# Manual Supplement

Manual Title: 7526A Users  
Print Date: July 2012  
Revision/Date:

Supplement Issue: **2**  
Issue Date: 8/12  
Page Count: 2

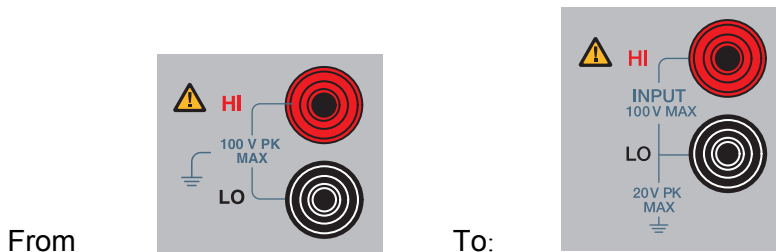
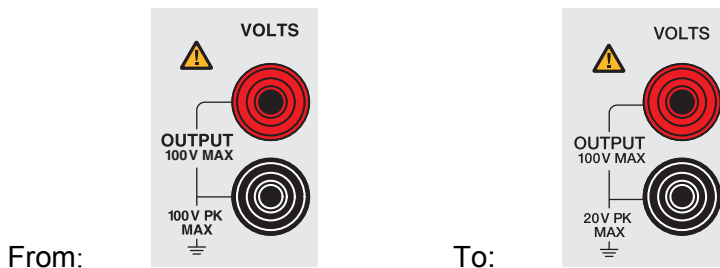
Throughout the manual, change all **Front Panel** figures:
